Technical Service Bulletin: TSB180024

Released Date: 28-Feb-2018

New Engine Piston Kits with Diamond Like Coated Piston Pins

Figure 1, Existing Piston Pin.

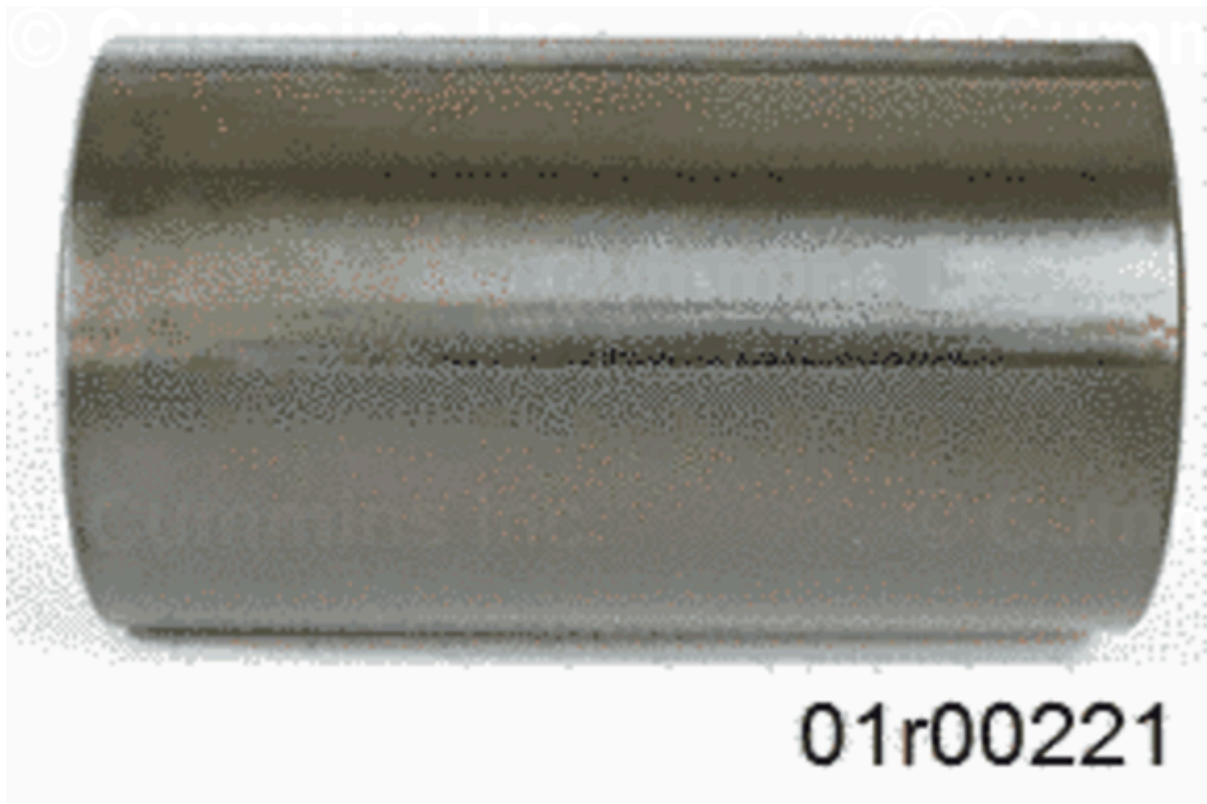
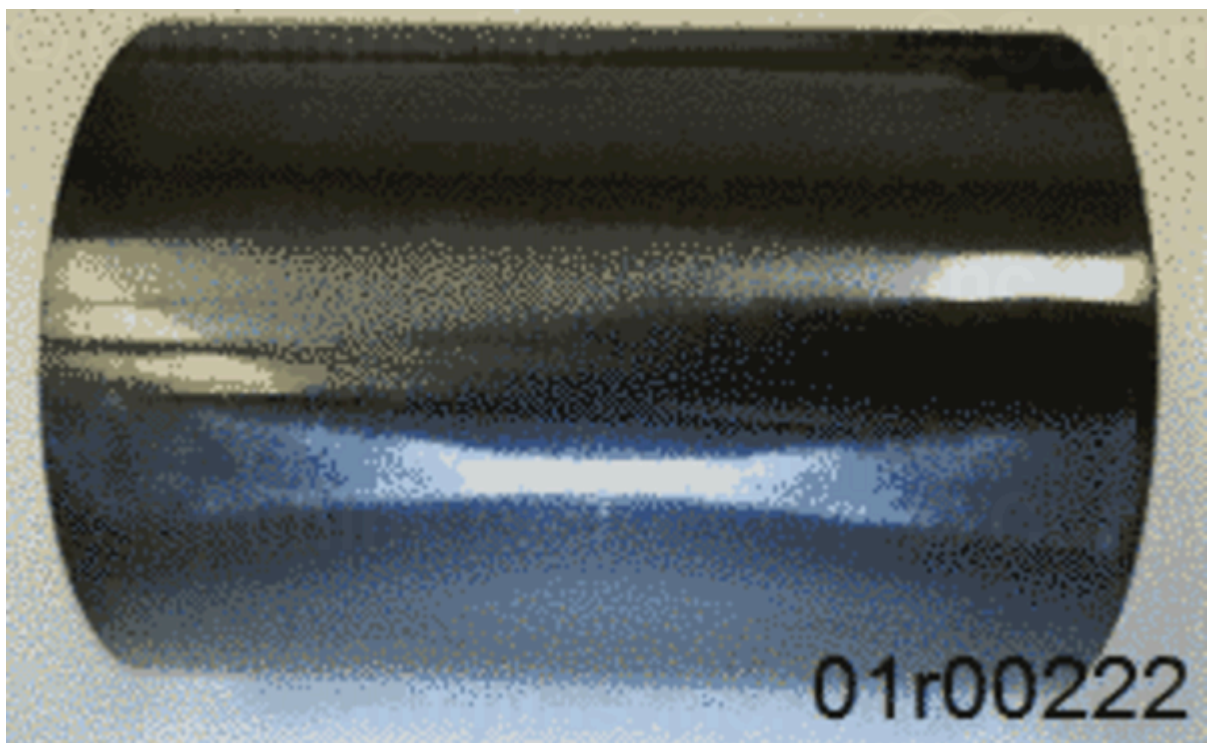
- A new diamond like coated piston pin and service kits are available.
- New diamond like coated piston pin is darker in color. See Figures 1 and 2 below.

New diamond like coated piston pin increases piston pin joint service life.
